Flight Procedures Cover Page	Task Action: FLIGHT CHECK	Task Type: IAP	Estimated Chart Date: 09/04/2025	APWS Task ID: 63449B19F23845F9BC8800F96505083B	APWS Project ID: 64ECA26FC3EA42F785F9456B5164B37D			
Procedure: Enroute: NO			Specialist: Hirst, Charles		Agreement Number:			
Airport ID: ME50			Airport City: MILLINOCKET		State: ME			
Facility ID:	Facility Type:	Flight Inspection Remark Type: New FC Slot

COPTER RNAV (GPS) M 353°

MILLINOCKET RGNL (ME50)

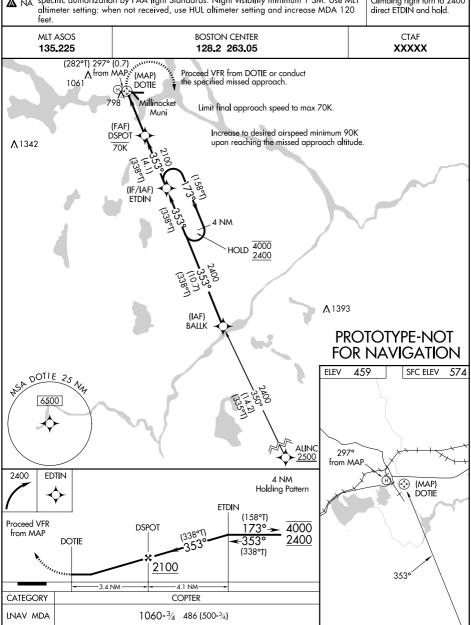
FLIGHT INSPECTOR REMARKS: Special Number YG-02-171-25. Millinocket Rgnl, Millinocket, ME, COPTER RNAV (GPS) M 350, ORIG. UNSAT for Fly-ability. VFR Segment releases the aircraft in a position where a hill/rise in terrain blocks the view to the helipad. Recommend either bringing the aircraft in along the VOR approach ground track or shifting the the ground track where the MAP is within 1 mile of the helipad, on the airport side of the helipad at or near 4538.98N/06841.87W.											ground						
IN-FLIGHT OBSTACLE REPORT																	
OBSTRUCTION I	D #: COO	RDIN	ATES OR 1	LOCATION:	GNS	SS ALTIT	TUDE (MSL):	BAR	ROMETI	RIC AL	LTITUD	E (MSL):	(MSL): HEIGHT ABOVE GROUND LEVEL:
